COMPONENTS LIST

For use with the QUAD 11 the following modifications are required:-

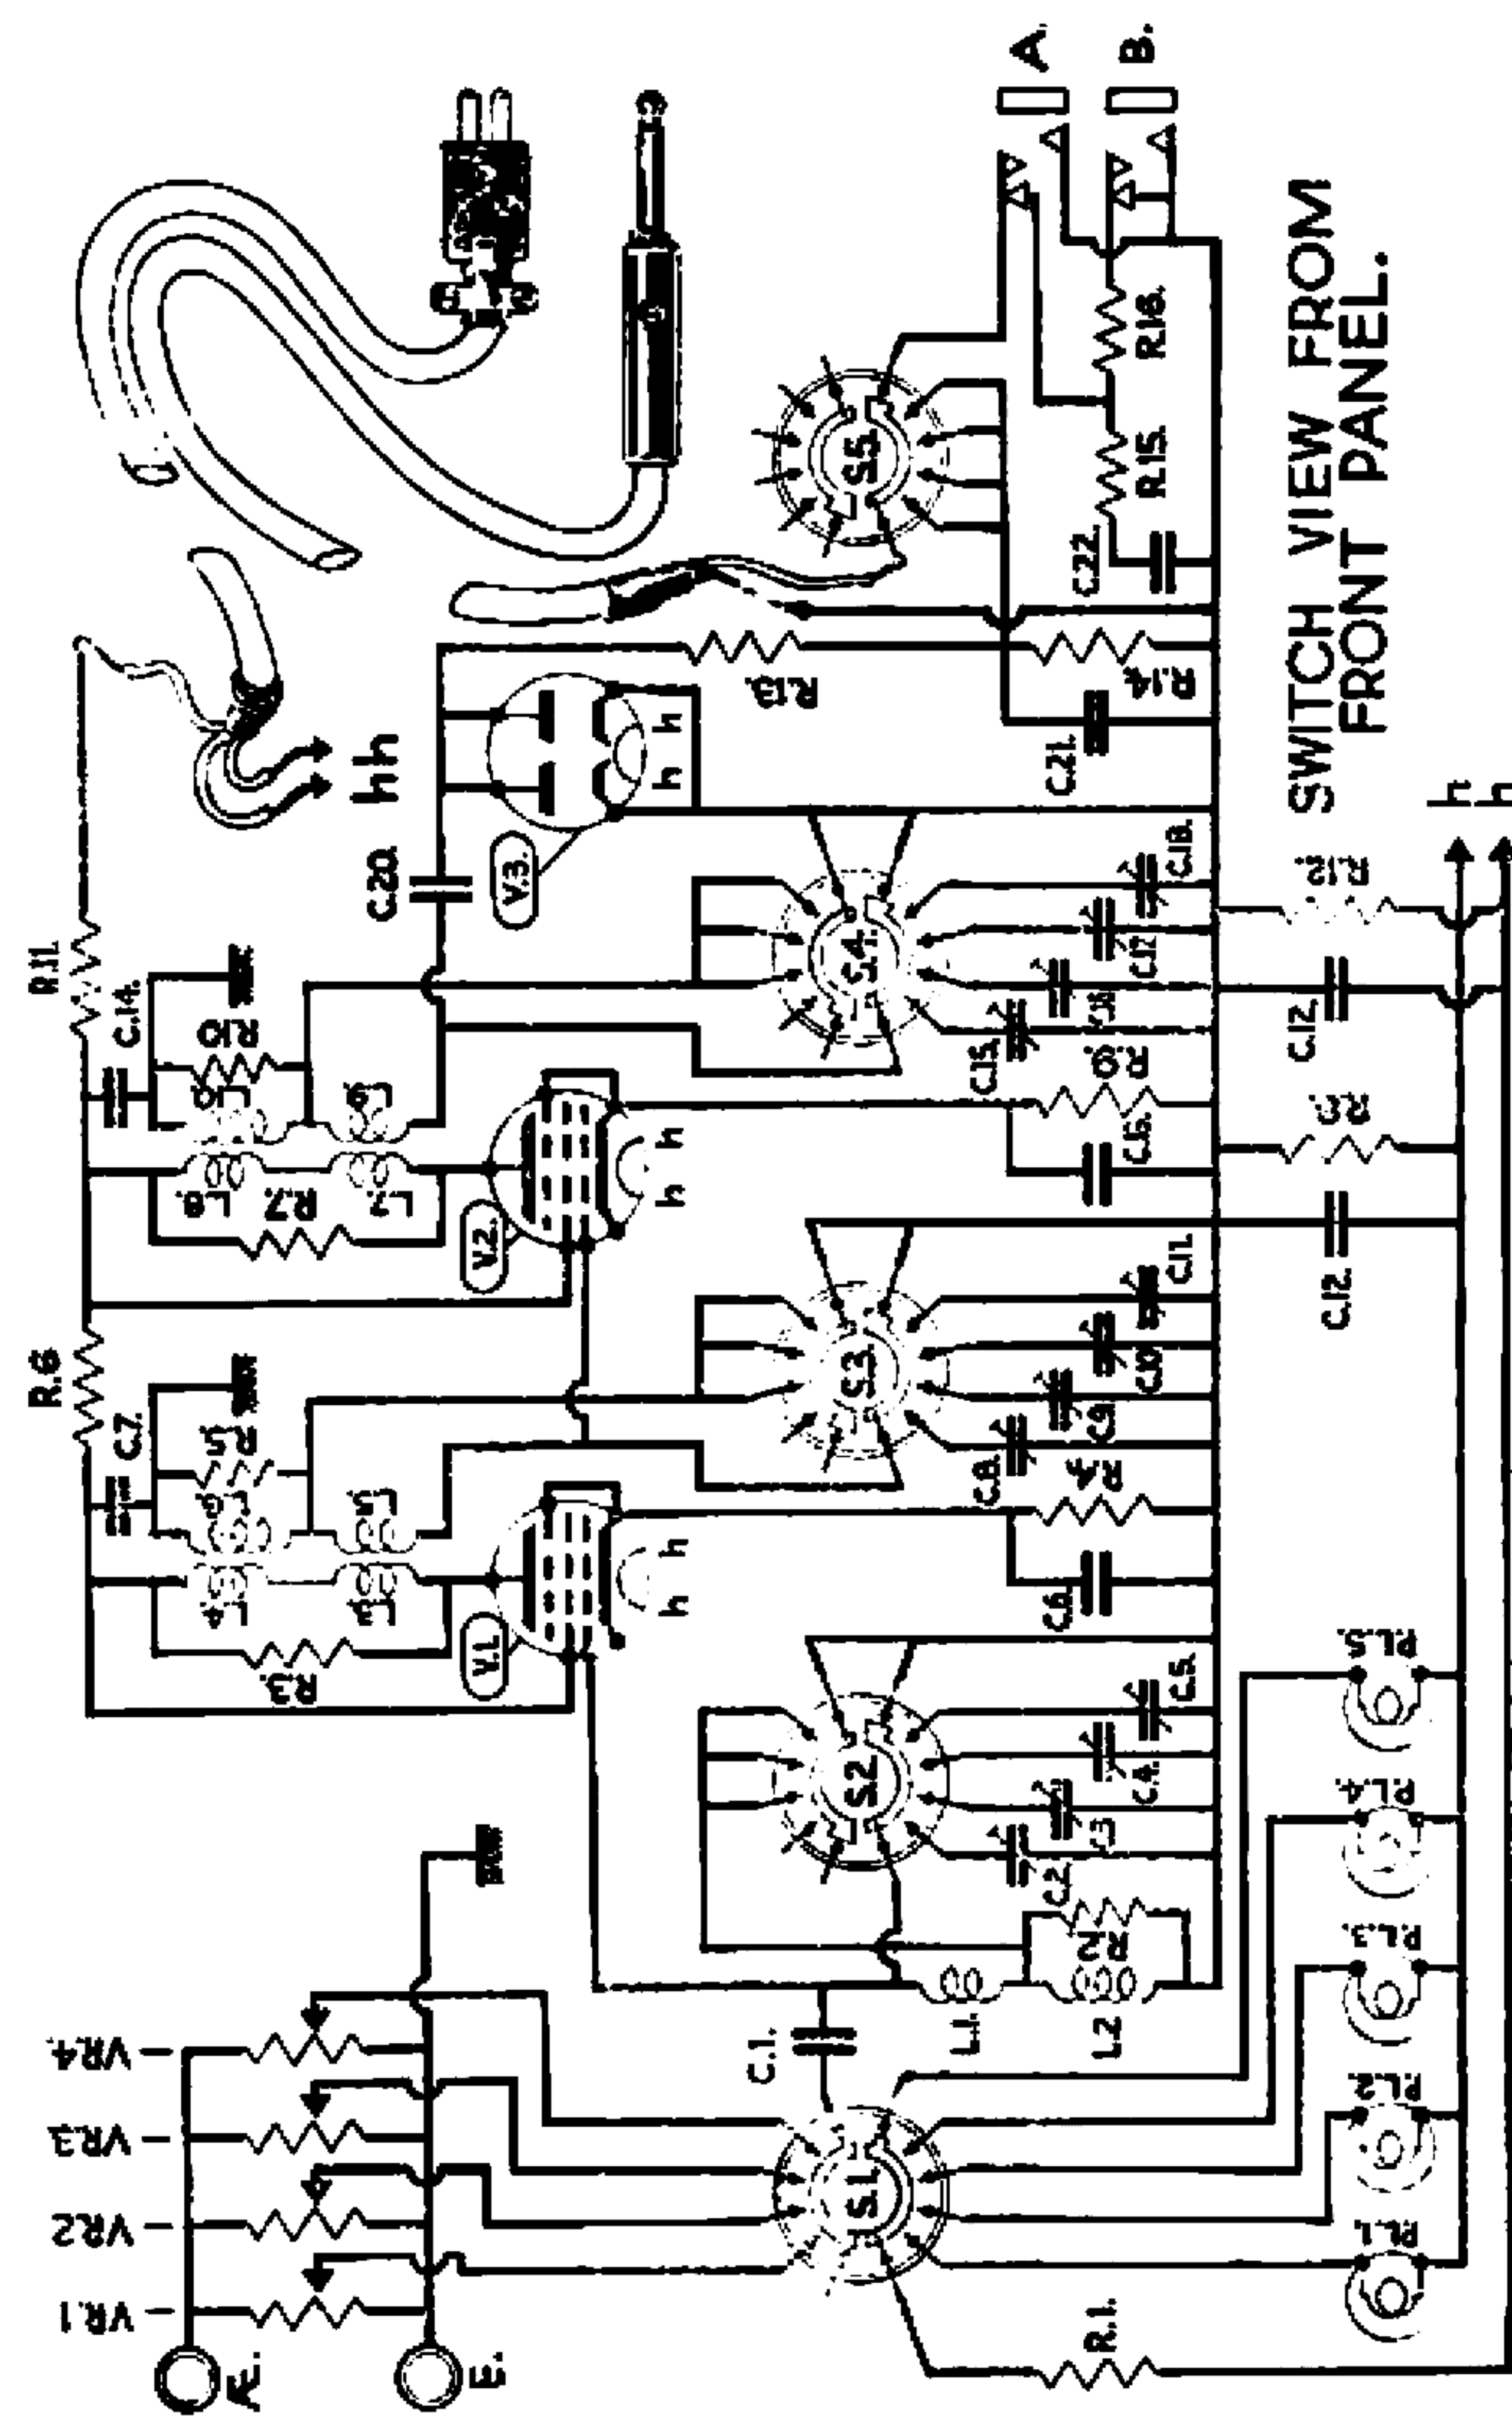
- (a) Change R.14 from 4,700 ohms to 47,000 ohms.
- (b) " C.21 " 600 pf to 100 pf
- (c) " 4 pin plug and jack to new types supplied with QUAD 11.
- (d) Fit 0.25 mfd condensor in series with output signal, i.e. between switch 5 and output lead.
